Application No. 10/534,747 Amendment dated June 25, 2007 Reply to Office Action of January 24, 2007

Amendments to the Drawings

REMARKS/ARGUMENTS

Appl.No. 10/534,747
Amdt. Dated June 25, 2007
Reply to Office action of January 24, 2007
Annotated Sheet Showing Changes

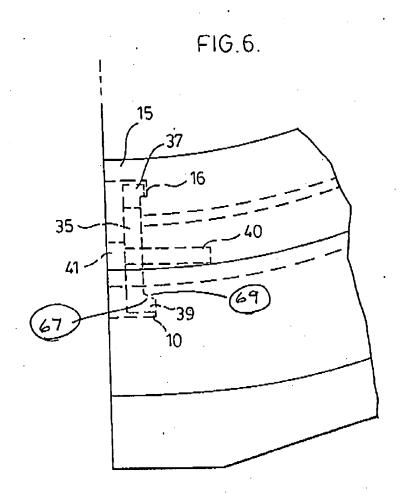
Element 45, 59, 61, 63 and 65 added
